INSPECTORS REPORT ON A LICENCE APPLICATION

TO:	Directors	
FROM:	Aoife Loughnane	Environmental Licensing Programme
DATE:	22 nd September 2010	
RE:	Application for review of Waste Licence from Indaver Ireland (Branch of Indaver NV), 4 Haddington Terrace, Dun Laoghaire, Co. Dublin. Licence Reg. W0167-02.

Type of facility:	Non-Hazardous Waste Incineration/Waste-to-Energy Facility
Classes of Activity (P = principal activity):	3 rd Schedule: 7, 8(P), 12 & 13 4 th Schedule: 3, 4, 9 & 13 (Note Class 8 is refused in the RD)
Quantity of waste managed (tonnes per annum, tpa):	200,000 tpa for incineration, 2,000 tpa for treatment in residue solidification plant.
Classes of Waste:	Non-hazardous household, commercial & industrial wastes
Location of facility:	Carranstown, Duleek, Co. Meath.
Licence review application received:	03/03/2009
Submissions:	3 Third Party Submissions & 1 Applicant Submission
EIS Required:	Yes
Article 14 Notices sent:	26/06/2009, 02/06/2010
Article 14 responses received:	23/07/2009, 31/12/2009, 18/06/2010
Additional information received:	04/08/2010, 17/08/2010
Site Inspection:	12/06/2009
Site Notice Inspection:	27/03/2009 (Patrick Morris, OCLR)

Figure 2. Site Layout Comparison

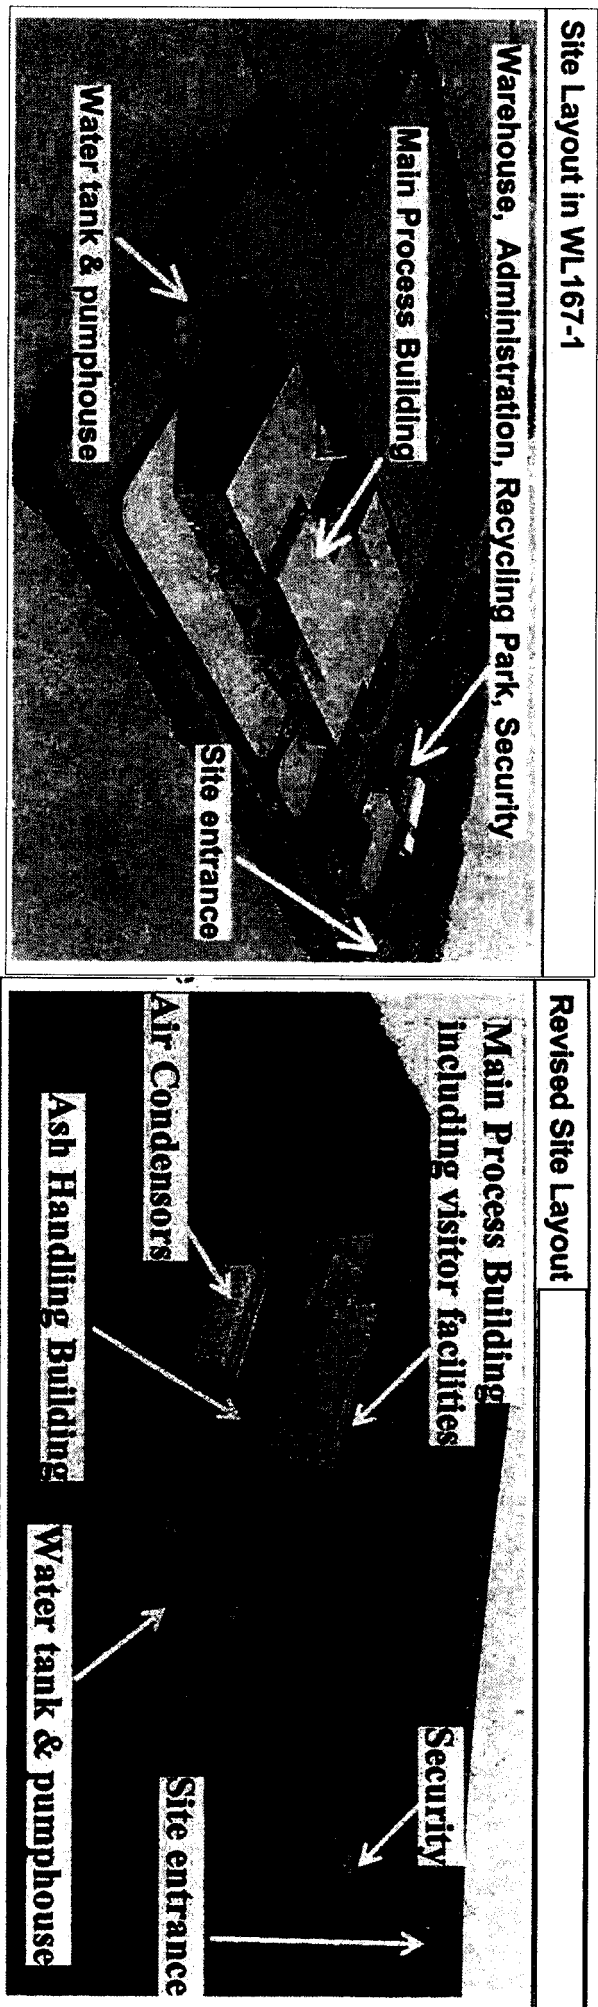
transformer compound and ESB substation, water storage tank and pumphouse, surface water attenuation pond, security gatehouse, two weighbridges, two Puraflo waste water treatment systems and associated percolation areas. Figure 2 in the Appendix shows a comparison of the site layouts as approved under W0167-01 and as revised in this application.

- Change in footprint, size and alignment of main process building.
- Removal of turbine building by situating turbine inside the main process building and relocating the air condensers to the north east of the process building.
